Thursday, April 11, 2024

## SUBDIVISION AUTHORITY AGENDA MEETING NO. 15

Subdivision Authority

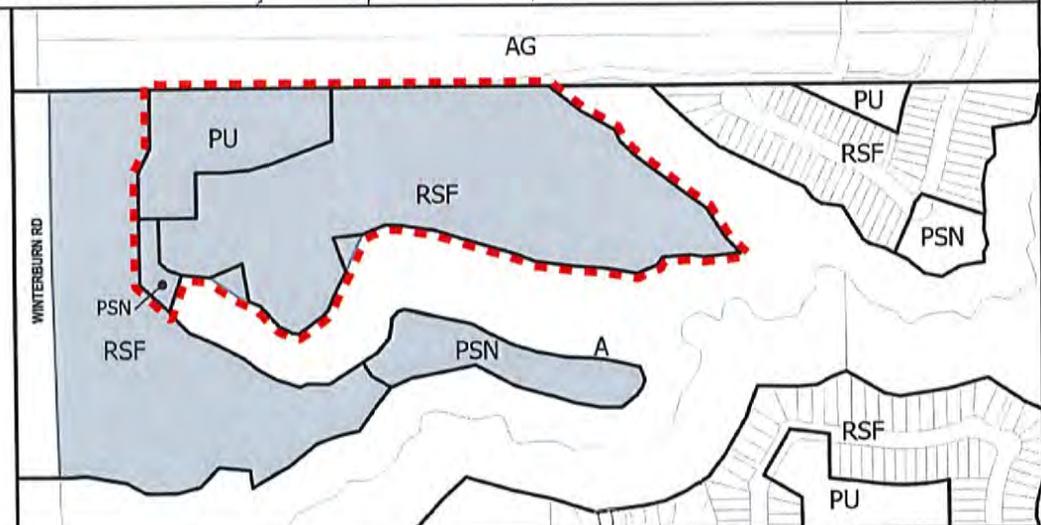
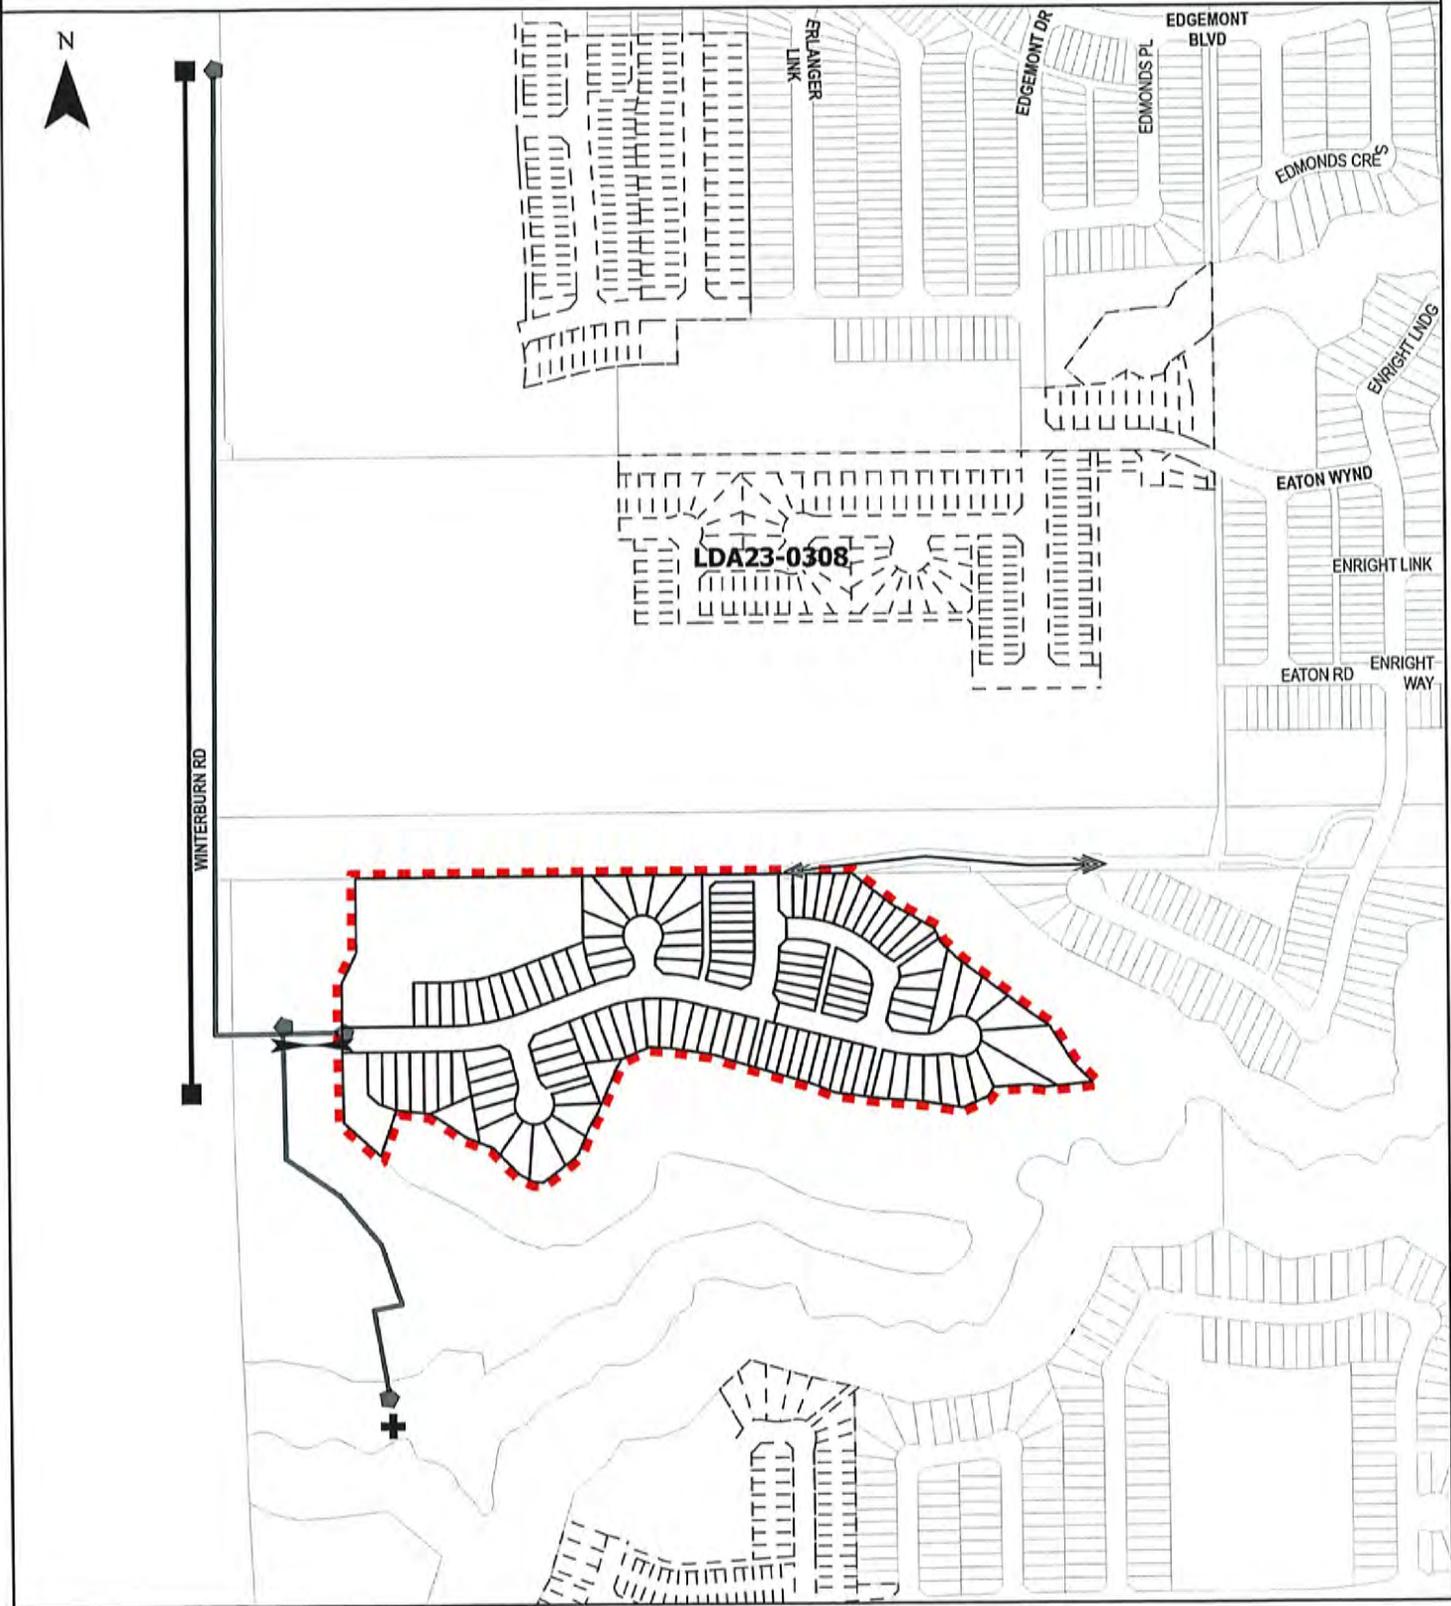
6. that the owner register a public access easement for the portion of the 3 m shared use path within Lot 2, Plan 782 3334, as shown on the "Conditions of Approval" map, Enclosure I. The City shall be a party to the easement;

7. that the owner dedicate road right-of-way to an approved Concept Plan or to the satisfaction of Subdivision and Development Coordination for Winterburn Road NW through the AltaLink Corridor, as shown on the "Conditions of Approval" map, Enclosure I;

8. that the subdivision boundary be amended to include the dedication of the Edgemont Green NW from the west boundary of the subdivision to Winterburn Road NW, to provide an access to Winterburn Road NW, as shown on the "Conditions of Approval" map, Enclosure I;

13. that the owner construct a 3 m asphalt shared use path within the top-of-bank setback area including "Shared Use" signage and landscaping, as shown on the "Conditions of Approval" map, Enclosure I, with connections to the existing shared use path network. Routing considerations will be reviewed through the submission of Engineering Drawing to the satisfaction of Urban Growth and Open Space Strategy (contact [ecologycircs@edmonton.ca](mailto:ecologycircs@edmonton.ca) for more information);

15. that the owner construct a 3 m hard-surface shared use path, within the Municipal Reserve lot, including lighting and bollards, as shown on the "Conditions of Approval" map, Enclosure I, with connections to the existing shared use path network. Lighting considerations will be reviewed through the submission of Engineering Drawing to the satisfaction of Urban Growth and Open Space Strategy (contact [ecologyecircs@edmonton.ca](mailto:ecologyecircs@edmonton.ca) for more information);

17. that the owner pay for the installation of traffic signals, as shown on the "Conditions of Approval" map, Enclosure I. The City of Edmonton shall complete the signal design, and the City's Electrical Services Contractor must install the signals as per the agreement between the City of Edmonton and the Electrical Services Contractor. The timing of the traffic signals installation will be at the direction of City Operations. If traffic signals are not deemed warranted by City Operations within 5 years of signing the Servicing Agreement, the owner will be required to provide payment to the City of Edmonton for the installation of traffic signals at that time to fulfill this obligation;

21. that the engineering drawings include a wildlife crossing, in accordance with the City of Edmonton's Wildlife Passage Engineering Design Guidelines, to the satisfaction of Subdivision and Development Coordination, as shown on "Conditions of Approval" map, Enclosure I. Wildlife crossing requirements will be reviewed through the submission of Engineering Drawing to the satisfaction of Urban Growth and Open Space Strategy (contact [ecologyecircs@edmonton.ca](mailto:ecologyecircs@edmonton.ca) for more information);

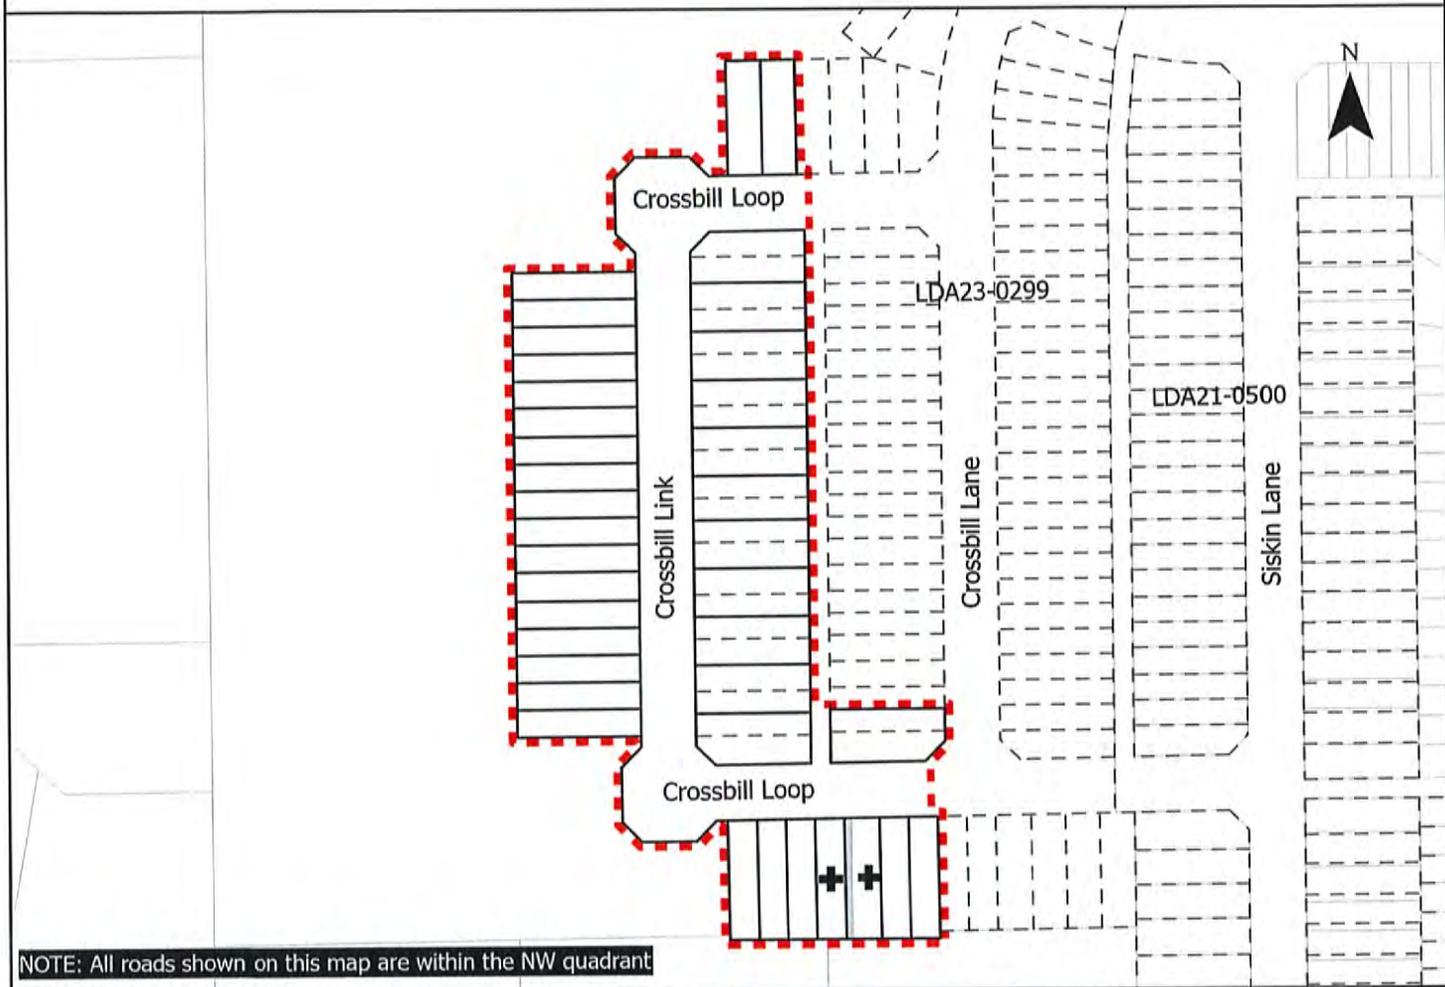
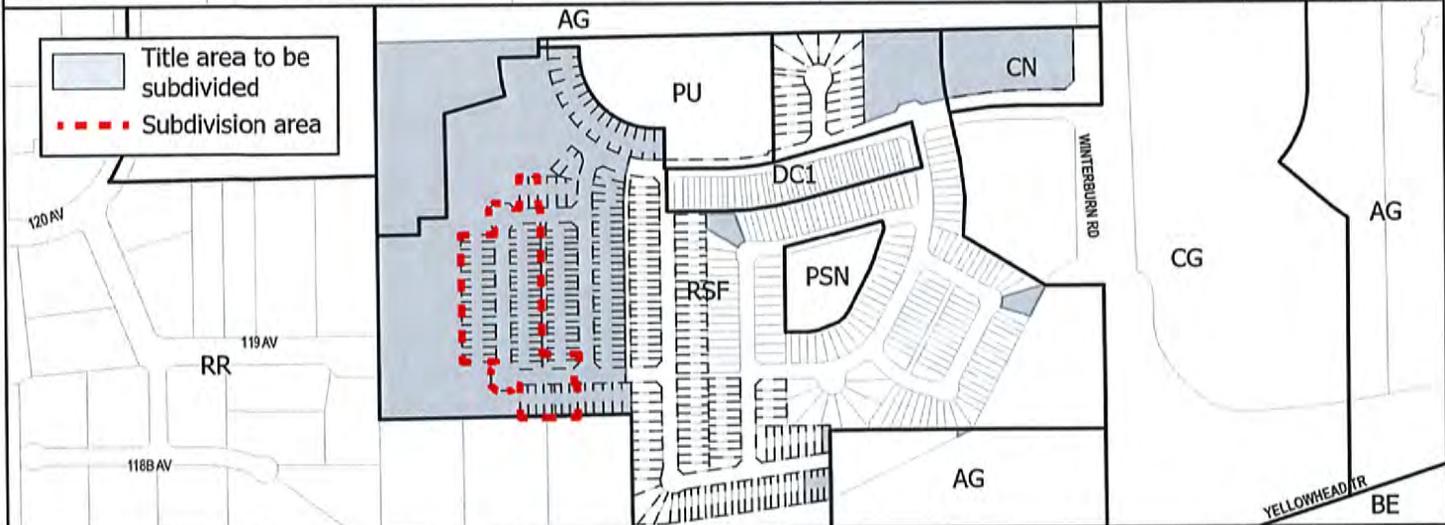
3. that the approved subdivisions LDA23-0299 be registered prior to or concurrent with this application to provide the logical roadway extension;
4. that the owner register a 3.5 m drainage easement for the provision of storm sewers on private property, as shown on the "Conditions of Approval" map, Enclosure I;

LDA18-0536

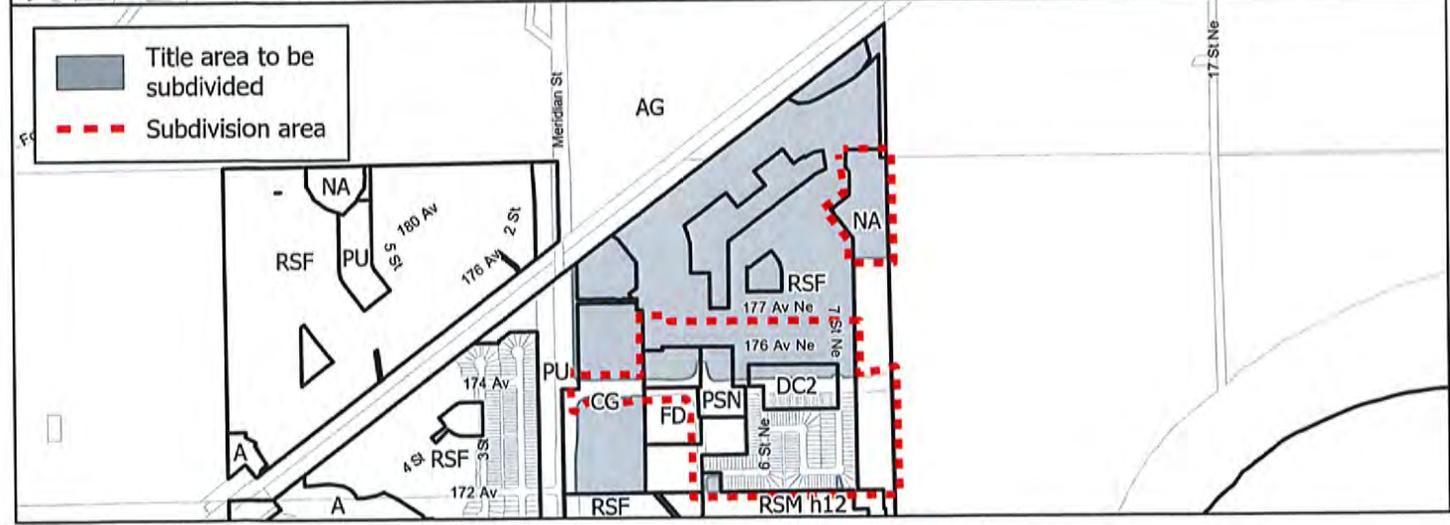
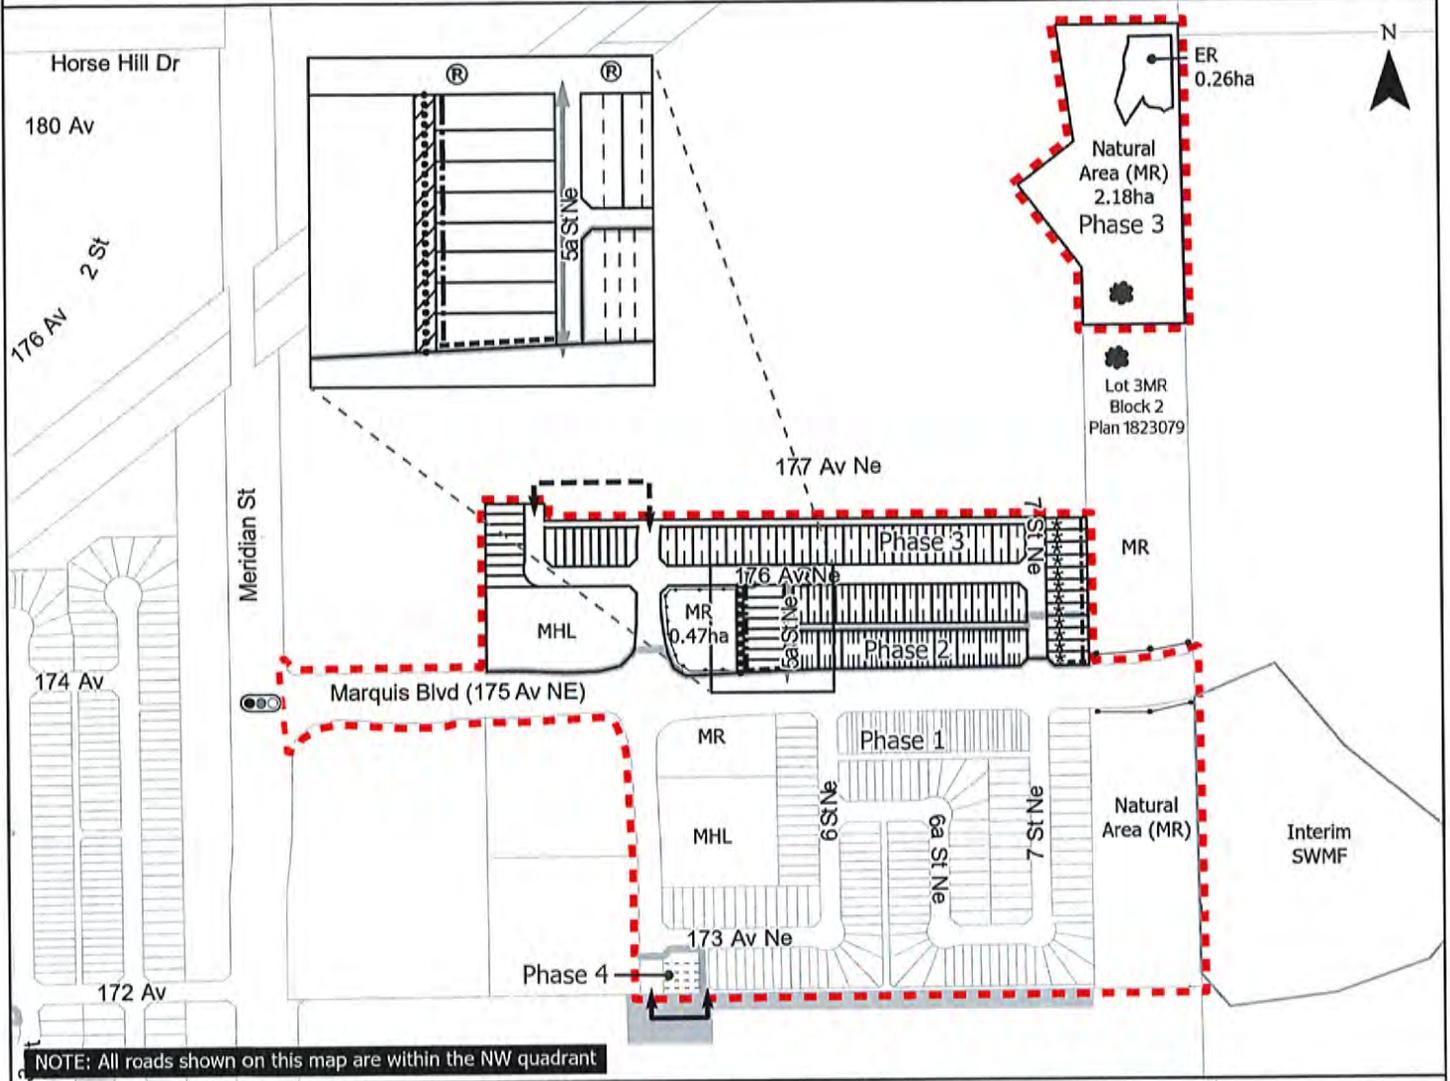
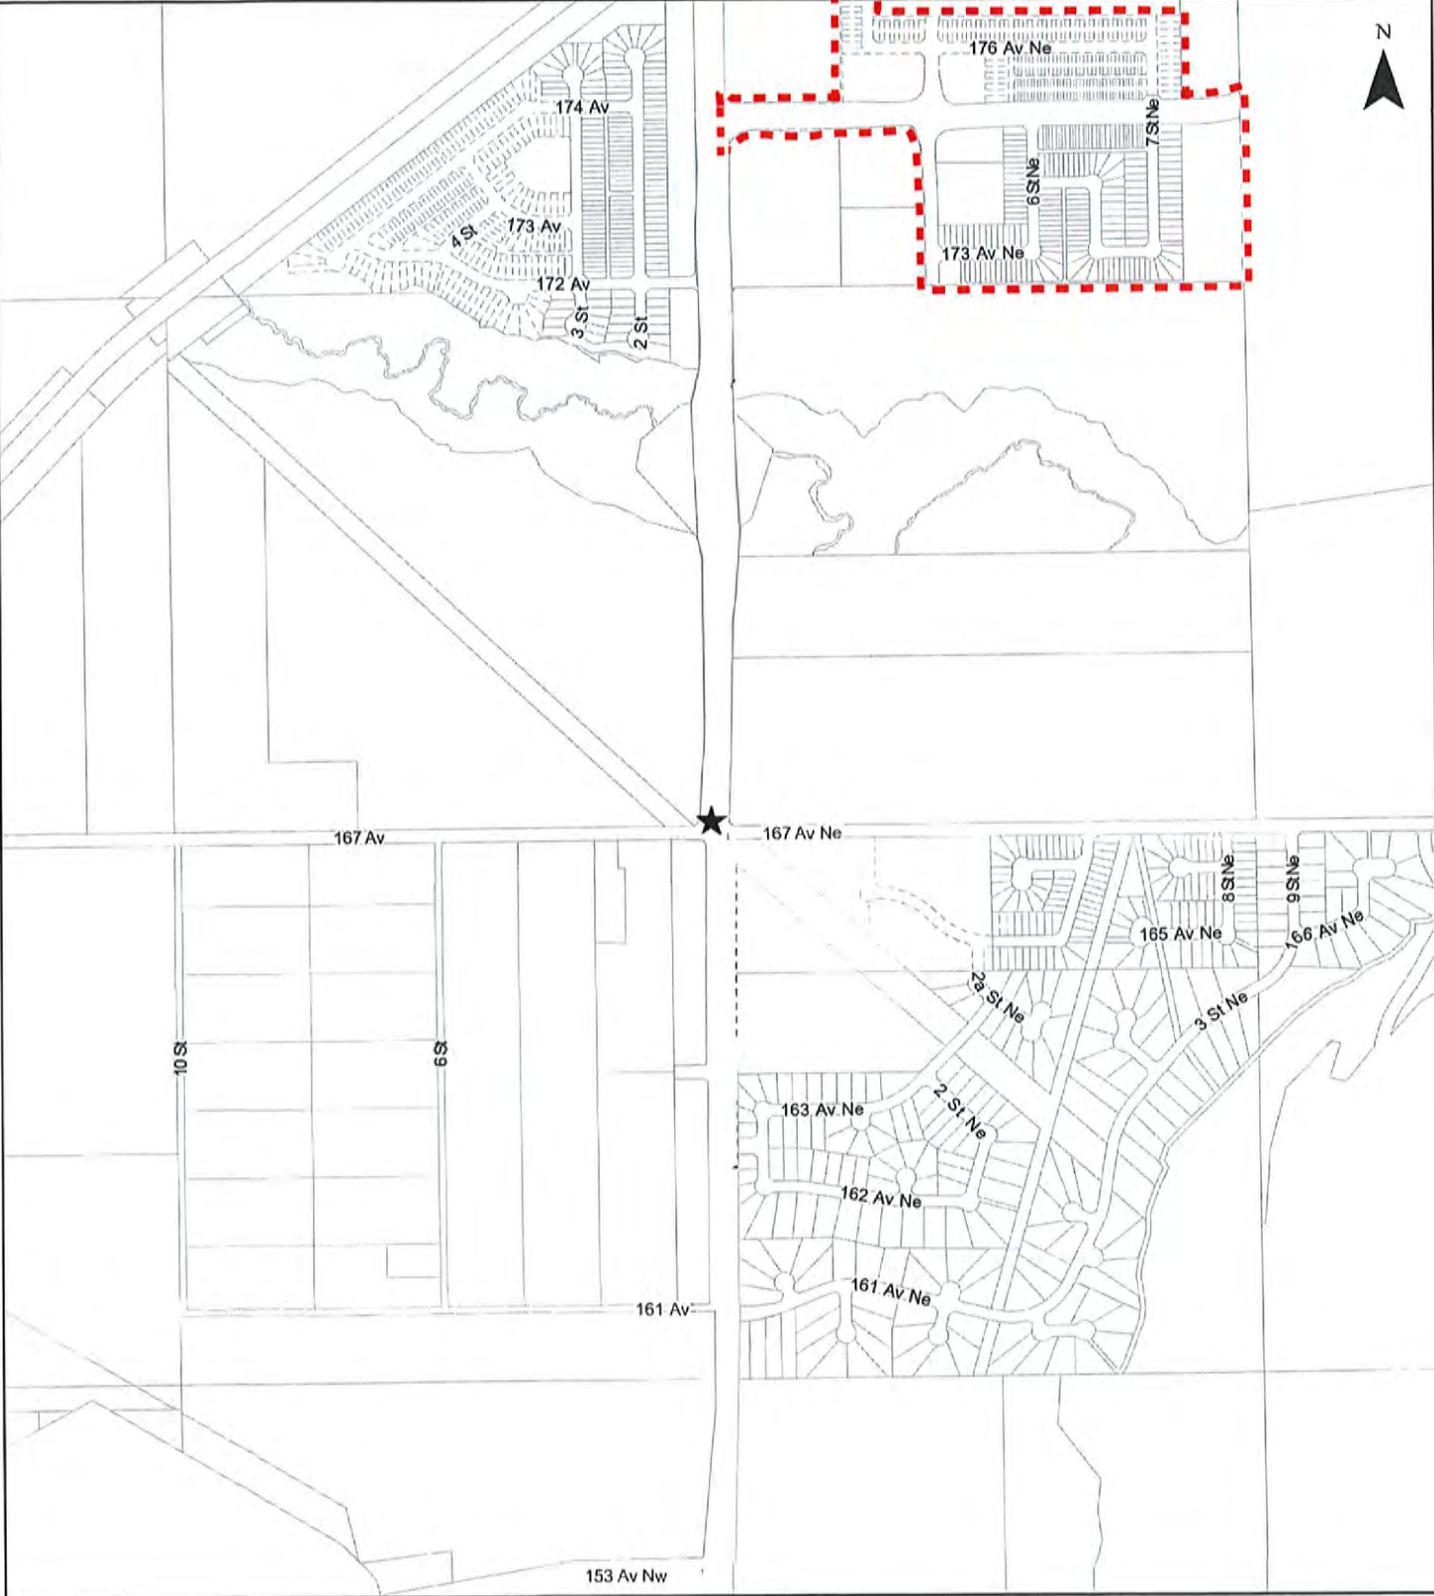
This is the third Change Request for this subdivision. This Change Request seeks to add ten additional residential lots within Phases 2 and 3, adjusts the phasing line slightly between Phases 2 and 3, moves the 2.18 ha MR lot and 0.26 ha ER lot from Phase 2 to Phase 3, and adds conditions to address the damage to the tree stand south of the proposed 2.18 ha MR lot. The second Change Request was conditionally approved by the Subdivision Authority on June 17, 2021 (increase residential lot count and add one phase). Following the second Change Request, a decision by the Subdivision and Development Appeal Board (September 29, 2021) removed a condition to upgrade a portion of Meridian Street. The first Change Request was conditionally approved by the Subdivision Authority on February 6, 2020 (increase residential lot count). The original subdivision was conditionally approved by the Subdivision Authority on April 25, 2019.

7. that the owner be permitted to register this plan of subdivision in phases in sequential order, as shown on the "Conditions of Approval" map, Enclosure I;

8. the owner shall register a restrictive covenant against the lots backing onto the Natural Areas in order to maintain the health and sustainability within said Natural Areas in accordance with the approved Natural Area Management Plan, to the satisfaction of Urban Growth & Open Space Strategy (contact [ecologyecircs@edmonton.ca](mailto:ecologyecircs@edmonton.ca)), in favour of the City of Edmonton, as shown on the "Conditions of Approval" map, Enclosure I; and

7. that the owner construct all roadways to an approved Complete Streets design and cross-section, as shown on the "Conditions of Approval" map, Enclosure I. The Complete Streets design and cross-section details for the roadways will be determined through the engineering drawing review and approval process, and as a result, may require adjustments to the road right-of-way;

11. that the owner construct a 3 m hard surface shared use path with lighting (including the portion fronting the Natural Area on Marquis Boulevard), landscaping, and any transitional improvements in Phase 2, as shown on the "Conditions of Approval" map, Enclosure I. Preliminary plans are required to be approved for Marquis Boulevard prior to the approval of engineering drawings for arterial and subdivision, to the satisfaction of Subdivision and Development Coordination;
